UNITED STATES PATENT AND TRADEMARK OFFICE

Office Action Summary

10/747,602

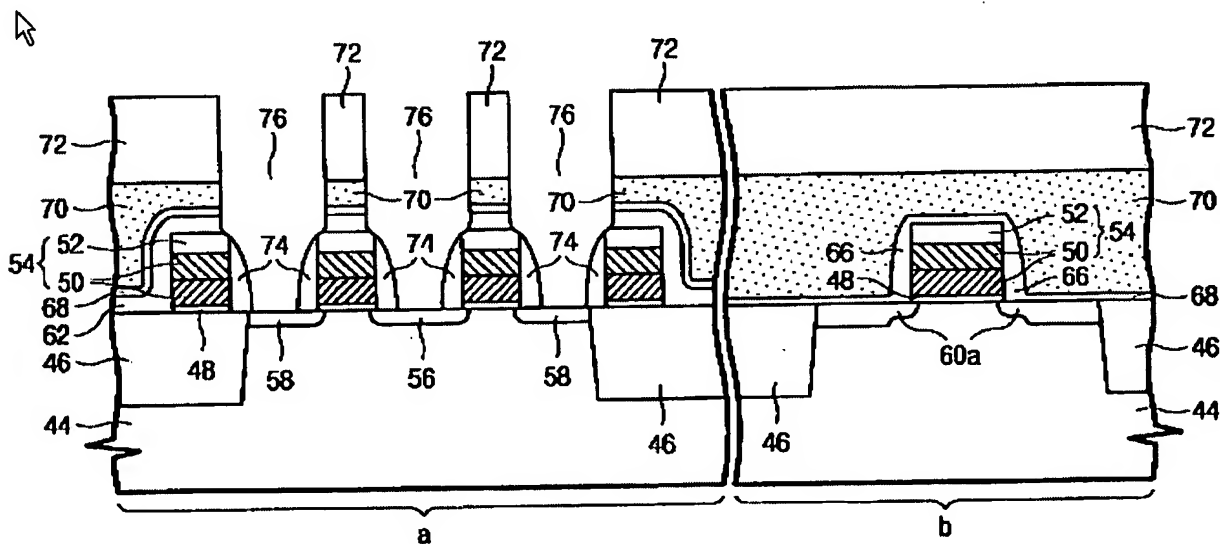
The applicant discloses the forming a sidewall oxide layer on the resultant substrate. Using the term "sidewall oxide layer" would give one that is skilled in the art the impression that this layer is only formed or deposited on the sidewall spacers of the substrate or that the applicant is referring to the sidewall spacers, since sidewall spacers can be formed from an oxide layer. Yet, the applicant shows in the drawings that this "sidewall oxide layer" is indeed deposited on the entire surface of the substrate

and not just the sidewall spacers. Applicant is required to change the term of "sidewall oxide layer".

Hwang, Figure 6A

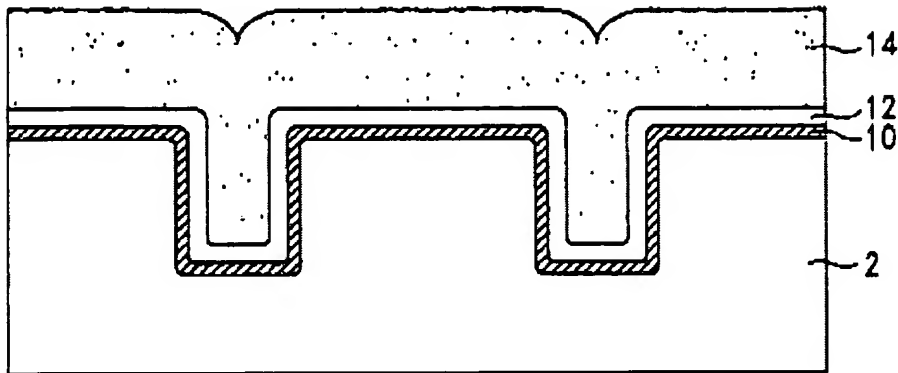
Regarding claim 1, Hwang teaches a method for fabricating a semiconductor device comprising of forming a gate oxide **48** and a gate electrode **50** on a semiconductor substrate, performing a first ion implantation process for the formation of a (lightly doped drain) LDD region **60a** in the substrate, forming spacers **66**, **74** on the sidewalls of the gate electrode, performing a second ion implantation process for the formation of a junction region **58**, **60a** in the substrate using the spacers as a mask, forming a trench **46** for device isolation by removing selectively the top portion of the substrate between the spacers, planarizing the gap filling insulating layer **70**, and removing selectively some part of the gap filling insulation layer to form contact holes **76**. See Hwang, figure 6A

Hwang fails to teach forming a sidewall oxide layer on the resulting substrate, forming a diffusion barrier on the sidewall oxide layer, and depositing a gap filling insulation layer over the diffusion barrier. Wu teaches forming a sidewall oxide layer **10**
